**Land north east of Junction 10 of the M42 Motorway / north of the A5, Dordon**

**Sam Oxley on behalf of North Warwickshire Borough Council**

**Rebuttal in relation to points in evidence by Jeremy Smith**

June 2024

## APPENDIX A: LOCATION AND EXTENT OF OFFSITE MITIGATION AREA

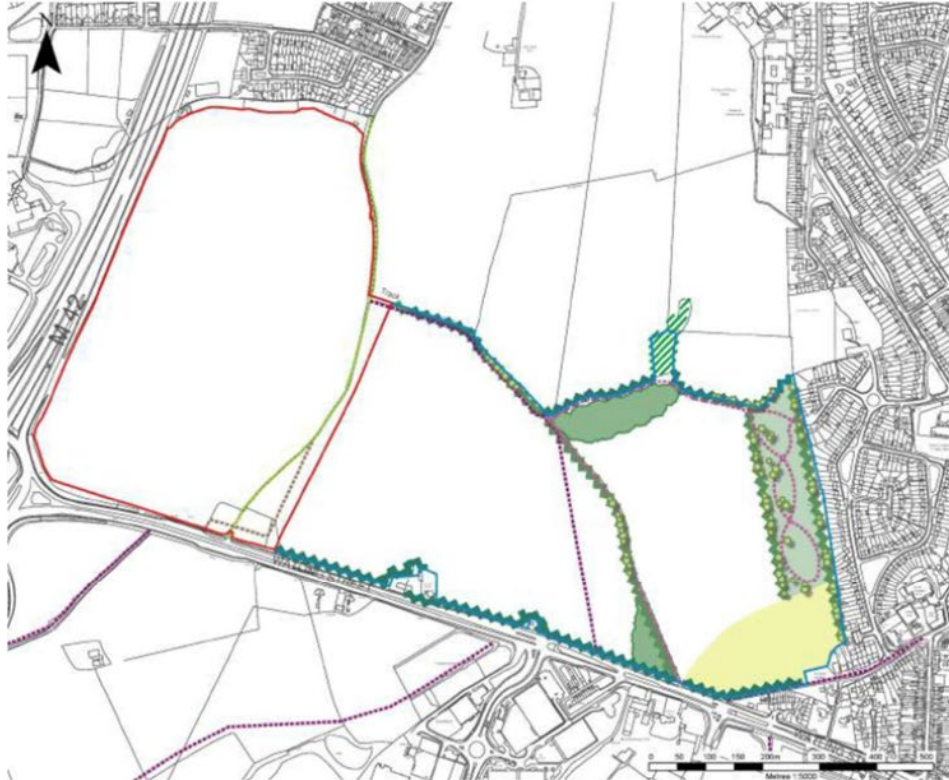
- 1.7 In his proof, J. Smith refers to an *“Offsite Mitigation Area of 41.66ha which would be provided to the east of the east of the appeal site, and this would include new woodlands, orchards as well as hedgerow planting and species-rich grassland”* (para 3.30) and the *“enhancement of the 41.66ha of agricultural land to the east of the site with new hedgerow and woodland planting and the creation of species-rich grasslands”* (para 7.37 and para 1.9 of the Summary). It is apparent that only 6.51ha of this would be set aside for additional planting, with 3.41ha of this being publicly accessible, as stated in paragraph 3.19 of the proof. In addition, it is noted that *“Hodgetts Estates has also suggested a condition which would change the use of the existing arable fields (outside of the proposed new POS proposed on the western edge of Dordon) to species-rich grassland”* (paragraph 3.21). This has not been included in the Offsite Mitigation Plan (reproduced below) and it is not clear how this would be delivered and if it would remain in perpetuity? For example, developing and maintaining species rich grassland from arable land requires long term expert management. The way in which the proposals are described by the appellant implies that they will be far more extensive and beneficial than is likely to be the case in practice.

- 1.8 The schematic drawing can provide no certainty and the extent to which the appellant relies on this to justify the development seems unbalanced.
